# MAMMOMAT 3000/3000 Nova

SP
Service	
Modification Instructions	
Drill a keying hole in the biopsy unit	
	© Siemens AG 2000 The reproduction, transmission or use of this document or its contents is not permitted without express written authority. Offenders will be liable for damages. All rights, including rights created by patent grant or registration of a utility model or design, are reserved.

Print No.: SPB7-230.092.18.01.02

Fig. 1

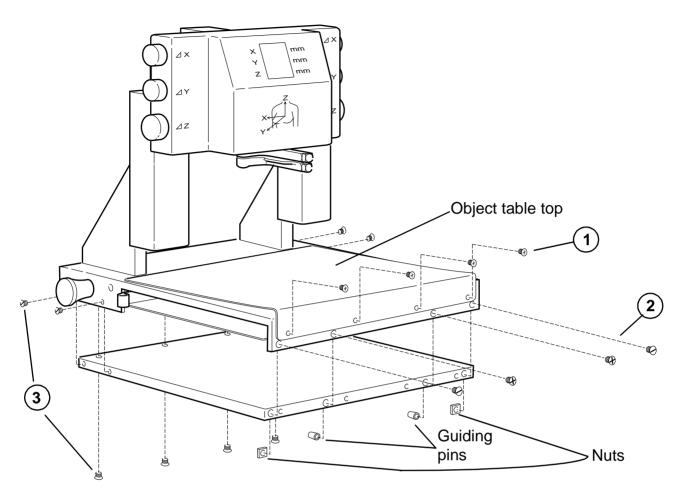
- 1. Remove the four screws holding the front edge of the object table top.
- 2. Carefully lift the front edge of the object table top to reveal the four screw placed behind it.

Remove the revealed screws, the two nuts and the two guiding pins.

- 3. Remove the bottom plate by unscrewing the eight remaining screws:
  - Two screws at either side of the biopsy unit.
  - Four screws at the bottom of the biopsy unit.

Fig. 2

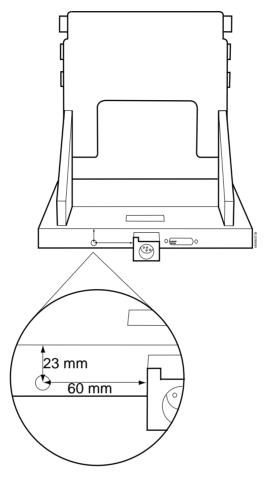
4. Drill a 8 mm keying hole in the biopsy unit. The distance shall be 23 mm from the top and 60 mm from the connector (Fig. 2). Fig. 3 can be used as a drilling template.
